TO: Members of the MAG Standard Specifications and Details Committee

SUBJECT: MEETING NOTIFICATION AND TRANSMITTAL OF TENTATIVE AGENDA

**MAG Standard Specifications and Details Committee**  
**TENTATIVE AGENDA**  
**May 1, 2013**

MEETING MINUTES FROM THE  
MARICOPA ASSOCIATION OF GOVERNMENTS  
STANDARD SPECIFICATIONS AND DETAILS COMMITTEE

### 8. Case 13-04: Revision to Detail 120 SURVEY MARKER

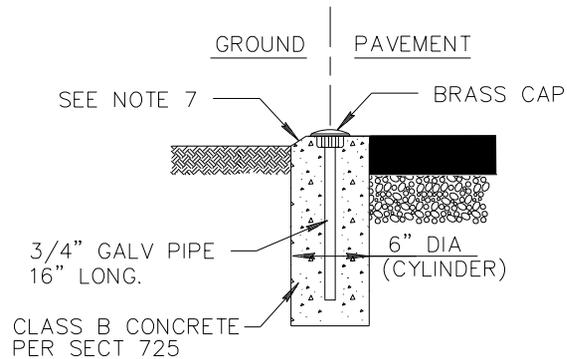
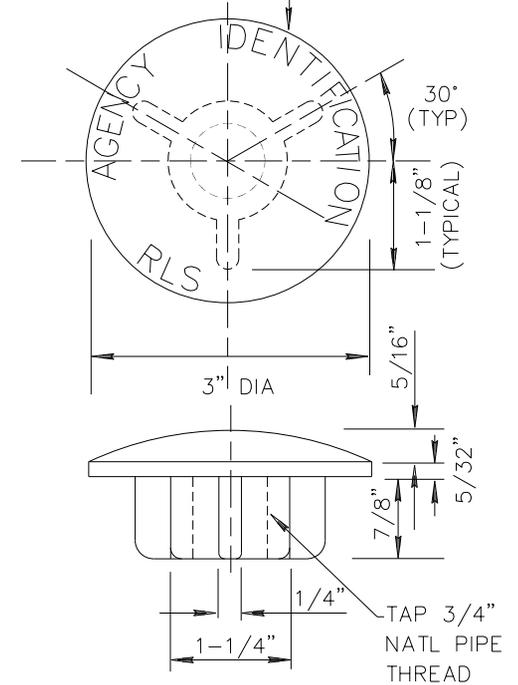
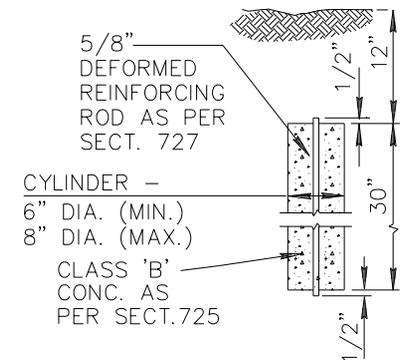
*Revise detail to prevent installation of survey markers that do not comply with requirements of state law.* Bob Herz presented an updated Detail 120: Survey Marker. He revised Note 2 on the

detail to remove “WHEN LOCATED IN PAVEMENT” since they are not always in pavement, and added “AND AT OTHER POINTS AS SHOWN ON PLANS.” Rod Ramos said he remembered a preference of showing on the TYPE ‘B’ detail with half of it not in pavement, since that was an option. Bob Herz said he would make that change to the drawing and asked to vote on the case at the next meeting.

1. TYPE 'A' TO BE USED AT INTERSECTIONS OF MAJOR STREETS & COLLECTOR STREETS, SECTION CORNERS, SECTION 1/4 CORNERS, CENTER OF SECTIONS, AND AT OTHER POINTS AS SHOWN ON PLANS.

2. TYPE 'B' TO BE USED (EXCEPT WHERE TYPE 'A' IS SPECIFIED) AT INTERSECTION OF STREET CENTERLINES, PC'S, PT'S AND PI'S OF CURVES, SECTION 1/16 CORNERS, SUBDIVISION CORNERS, CHANGE IN ALIGNMENT OF SUBDIVISION BOUNDARIES, AND AT OTHER POINTS AS SHOWN ON PLANS.
